**Champlain Hudson Power Express ("CHPE")
Environmental Management & Construction Plan
Notice of Major Change**

Project: Champlain Hudson Power Express

Segment: 08

Notice Number: 094

EXPRESS M - BETHLEHEM	Scale in feet
	PERMIT DRAWING NO.
C-310-A	DRAWING NO.
C-310	AS SHOWN
03/24/2023

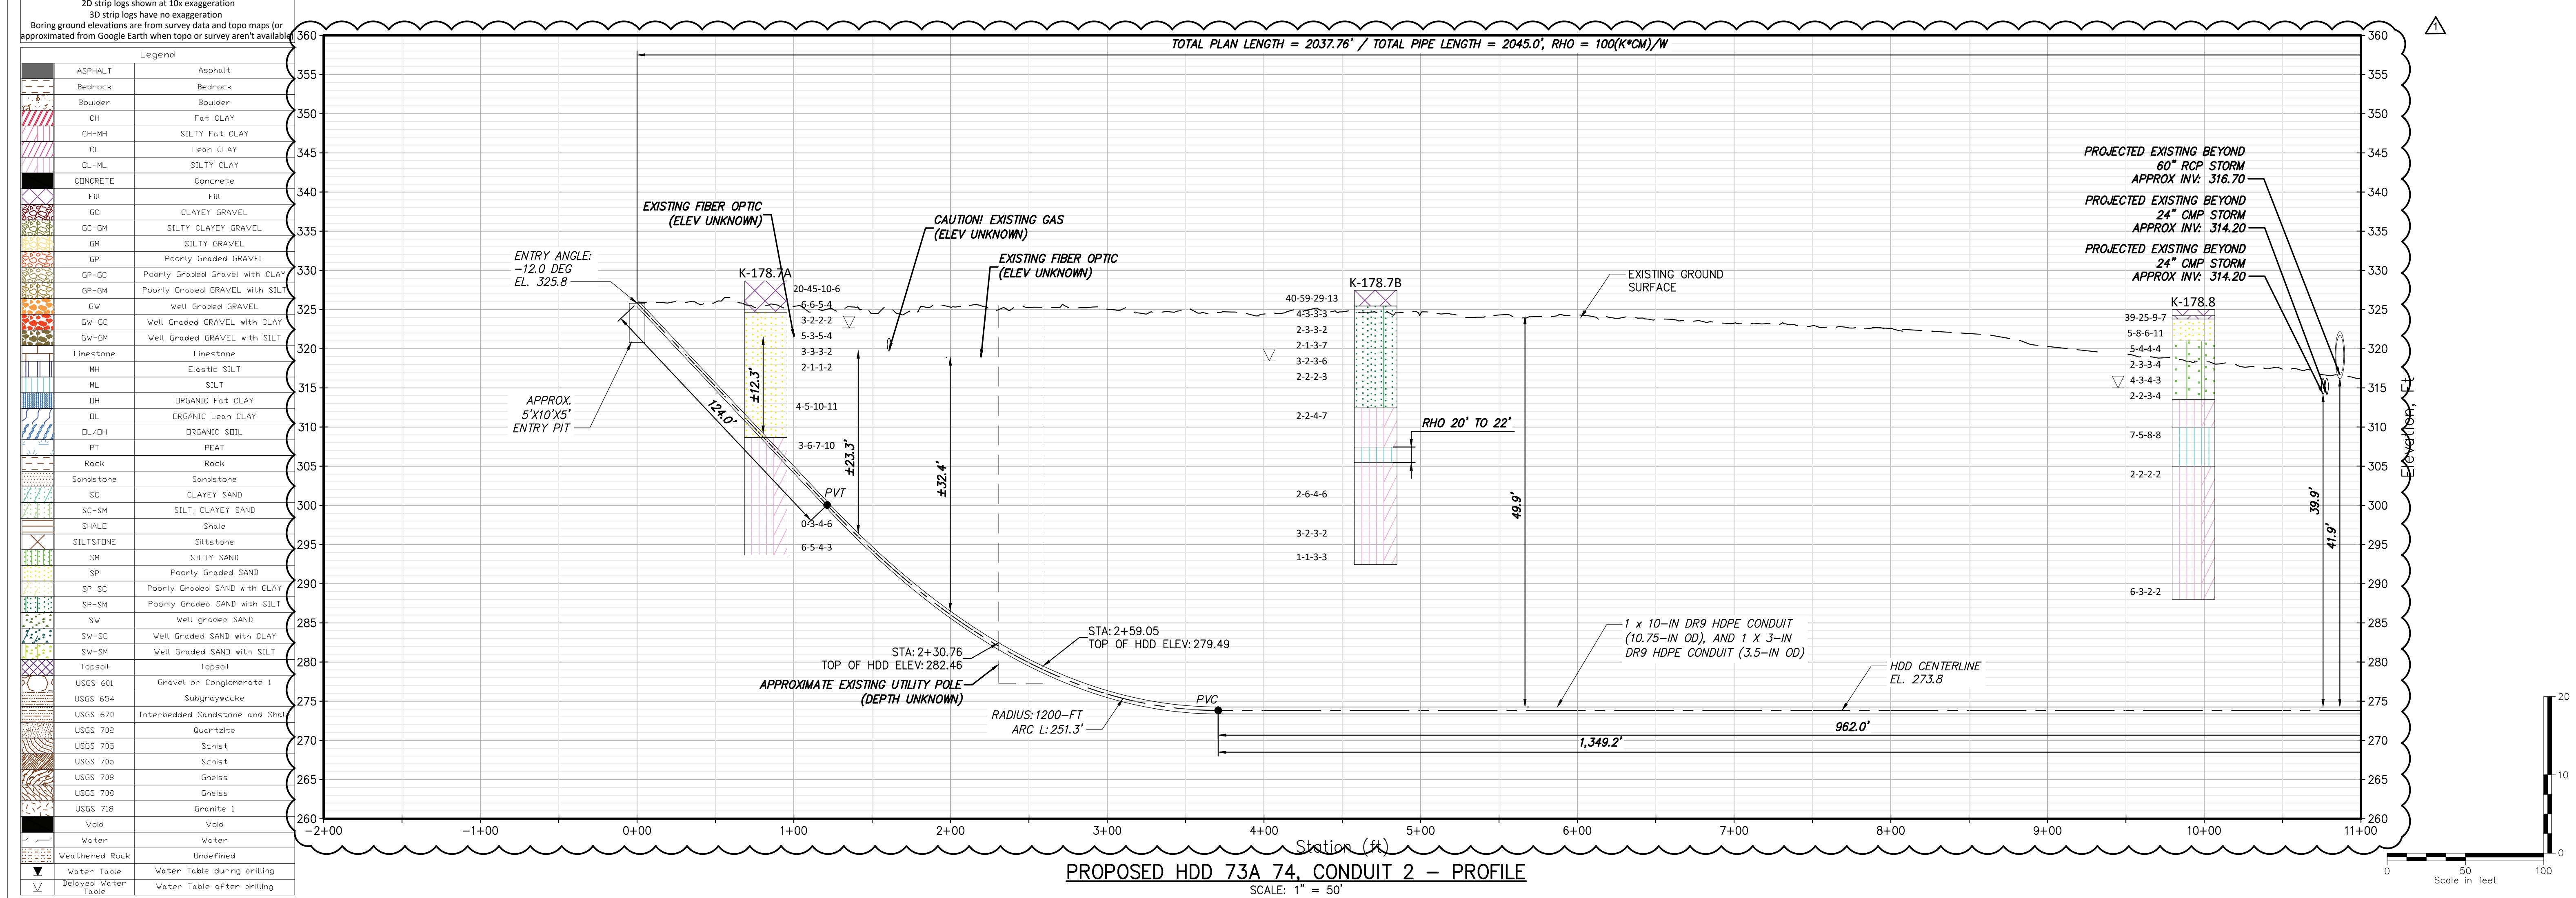
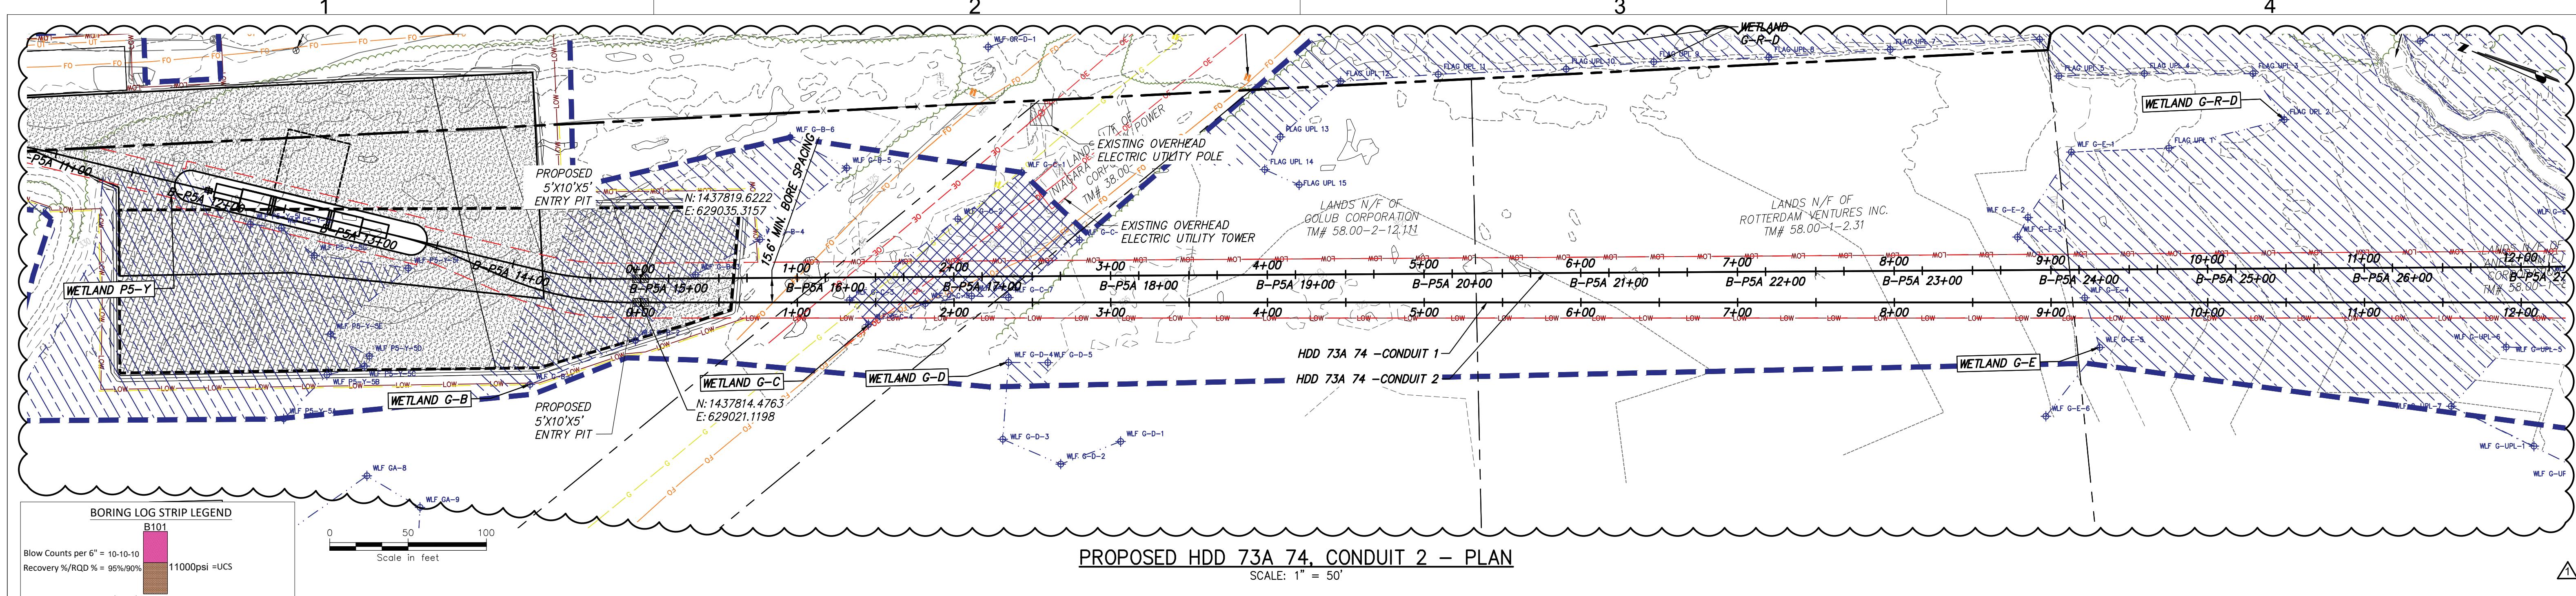
C-309	1	NDC-0020_HDD 73A Redesign	HDD 73.A/74 Alignment revised near National Grid Transmission Towers to achieve required clearances per NG Comments. The revised alignment starts at IFC Alignment STA. 50095+00.00, ends at IFC Alignment STA. 50127+85.00
C-310	1	NDC-0020_HDD 73A Redesign	HDD 73.A/74 Alignment revised near National Grid Transmission Towers to achieve required clearances per NG Comments. Additional utility survey was performed and incorporated for the "LANDS N/F OF LAWRENCE G. WHITE TM# 58.14-1-4.21". The revised alignment starts at IFC Alignment STA. 50095+00.00, ends at IFC Alignment STA. 50127+85.00
C-311	1	NDC-0020_HDD 73A Redesign	HDD 73.A/74 Alignment revised near National Grid Transmission Towers to achieve required clearances per NG Comments. The revised alignment starts at IFC Alignment STA. 50095+00.00, ends at IFC Alignment STA. 50127+85.00
C-312	1	NDC-0020_HDD 73A Redesign	HDD 73.A/74 Alignment revised near National Grid Transmission Towers to achieve required clearances per NG Comments. Additional utility
